Office Action Summary

10/679,128

LUMPKIN, WAYNE R.

DETAILED ACTION

Sheet 2 of 2

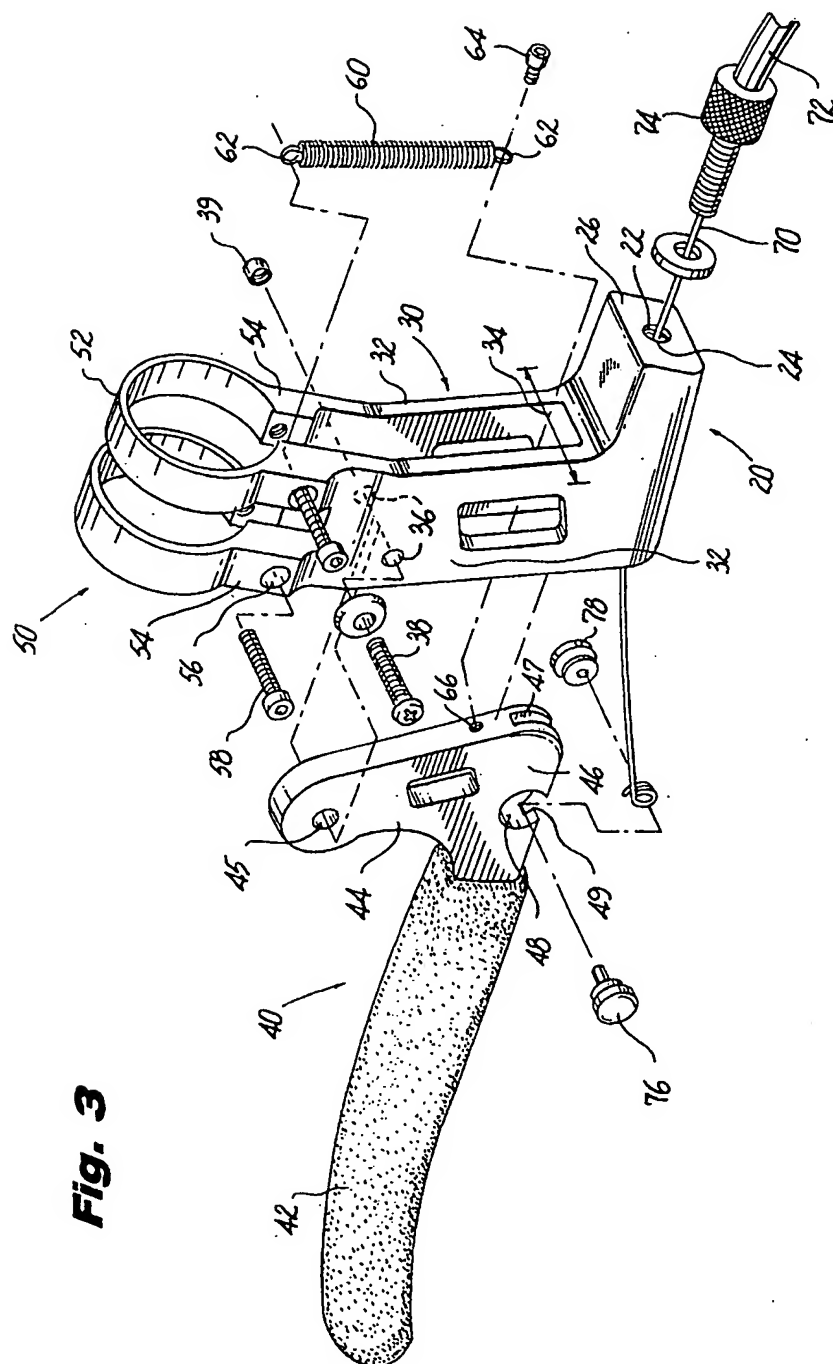
2. Claims 1, 4-10, and 11 are rejected under 35 U.S.C. 102(b) as being anticipated by Gelbein USP 5584210.

Gelbein discloses a(n):

- First arm (right side of 54)
- First threaded bore (right side of 56 on right side of 54)
- Second arm (left side of 54)
- Second threaded bore (left side of 56 on left side of 54)
- Screw (58)
- Head (100, See Figure 3 marked by examiner)
- Shank (110, See Figure 3 marked by examiner)
- Threaded portion (Threads toward the end of bolt 58)

- Clearance portion (Thread trough nearest the bolt head)
- Brake lever (40)
- Clamp (50)
- Housing (20)
